Important Service Advisory

**Redpoint™ and Auto-Belay Descenders
Part Numbers 10024873 and 10021806**

January 4, 2002

1(a) CORRECT

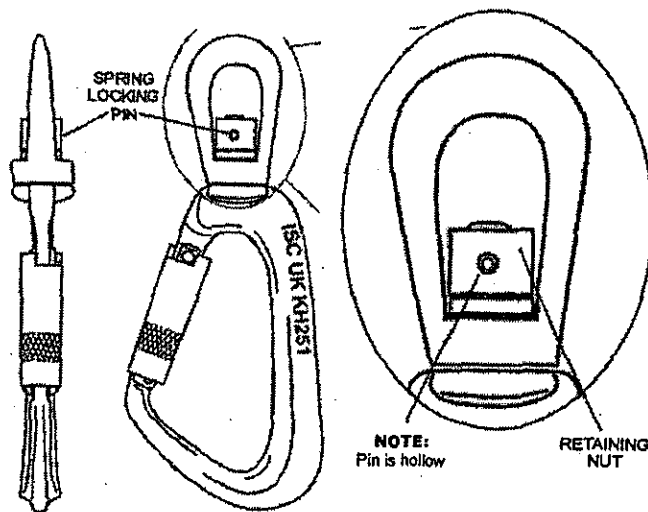
Check that the spring-locking pin in the swivel eye retaining nut is present and in the correct position. The pin should be below the level of the hole, or level with the hole. Note: Earlier versions of this carabiner have a hole drilled all the way through the nut and therefore the pin needs to be checked from both sides. Please see diagrams 1(a) and 1(b) (below) for correct and incorrect pin locations.

The end of pin is level with or below the surface of the nut.

1(b) INCORRECT

The pin is missing, or as shown below, the end of the pin sticks out above the surface of the nut.

If the pin is missing or if the end of the pin sticks out of the hole, immediately stop using the descent device and return it to MSA Rose.
